**AL KASIK LOCATION COMMAND
AL KASIK, IRAQ**

**SIGIR PA-09-182
OCTOBER 16, 2009**

Al Kasik Location Command

Summary of Report: PA-09-182

Figure 8. Schematic of pallet rack configuration and layout (Courtesy of USACE)

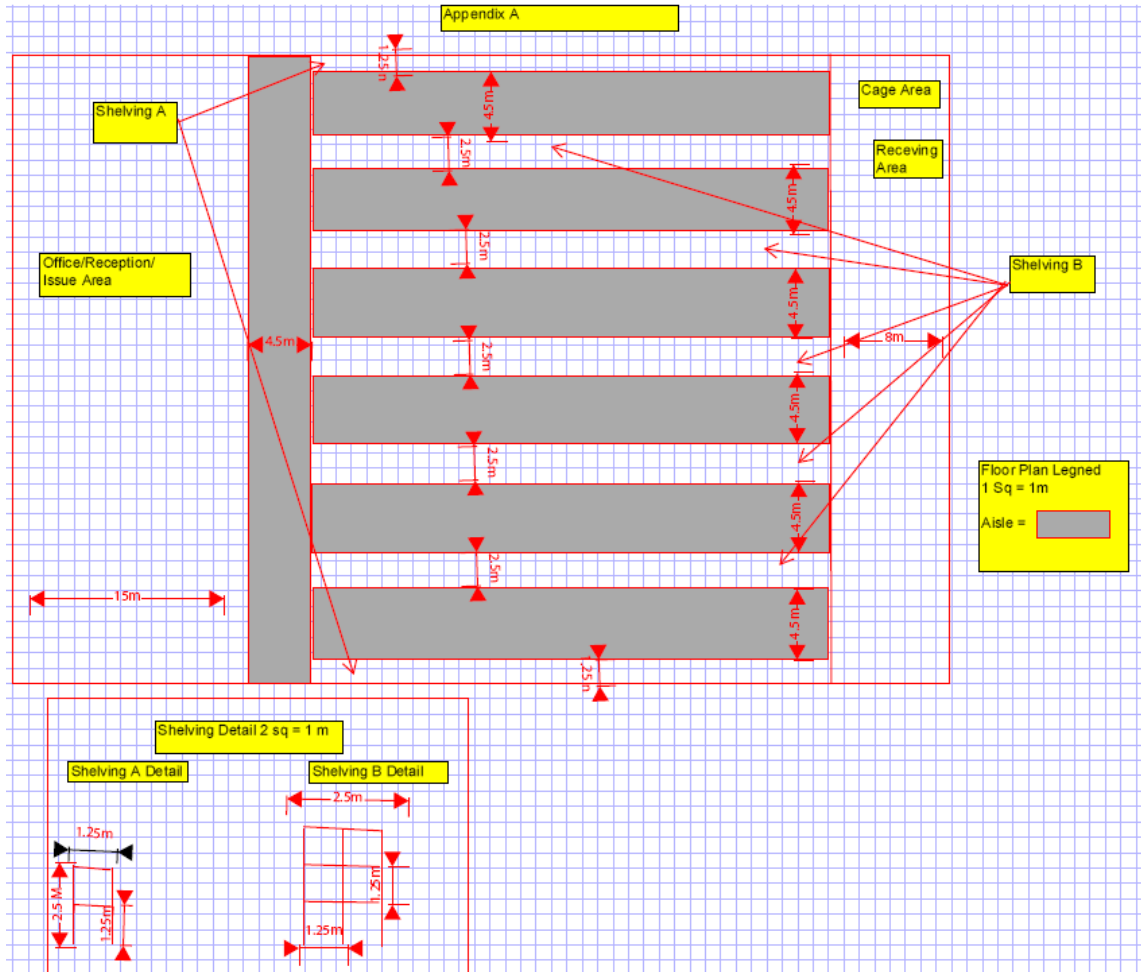
The SOW did not specify the size of the base plate for the rack legs. The dimensions of the base plate are critical in determining the allowable capacity of the concrete floor slab. To prevent cracking and failure of the slab, the base plate sizes should be specified based on the thickness of the existing slab. The information provided by GRN did not include any submittals for the pallet rack system.

Site Photo 11. Site grading for diesel storage at the distribution point

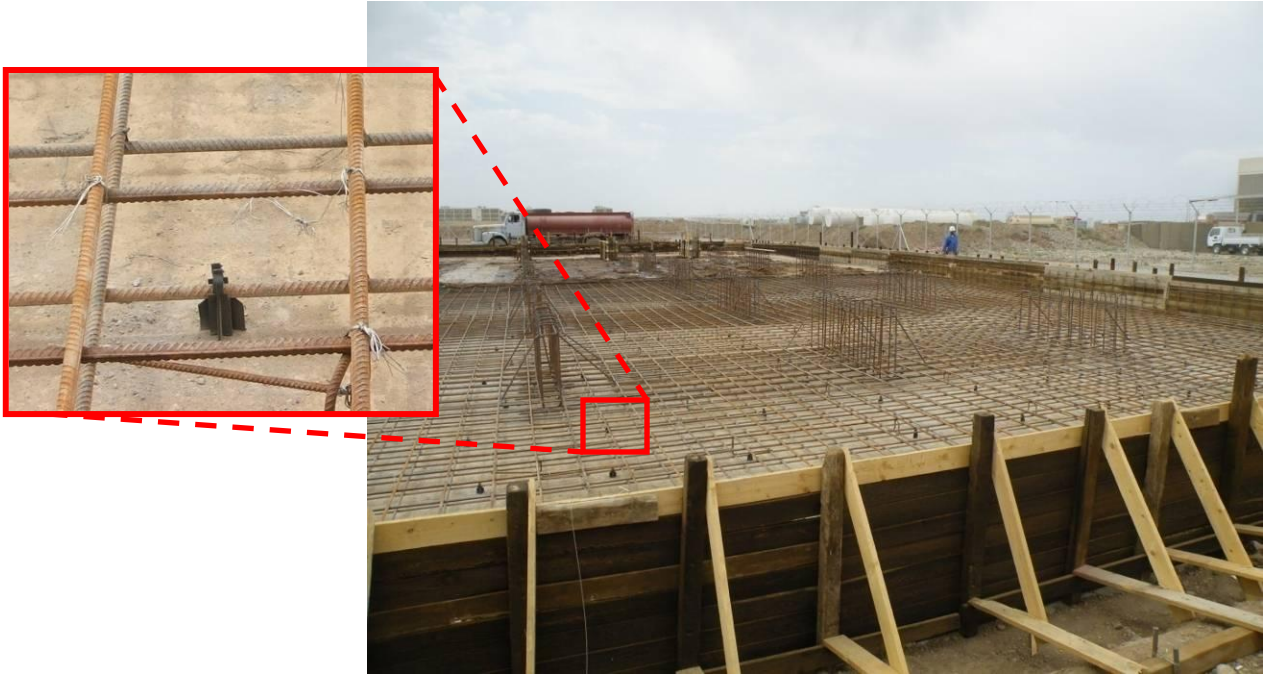
During the inspection of the raft foundation, SIGIR discovered one issue. It appeared that the contractor placed a construction joint near the middle of the foundation slab. It did not appear that provisions were made to continue the reinforcing steel through the construction joint or provide fuel proofing. There was also no evidence of a shear transfer mechanism at the joint—such as dowels or a shear key—and no fuel stop was noted.

The GRN Mosul Area Office personnel stated that the contractor would perform a final check of the rack system after construction completion to verify that all bracing is installed and that all legs are securely fastened to the floor slab. The other issues would be addressed throughout the project, and corrective action would be taken as necessary.
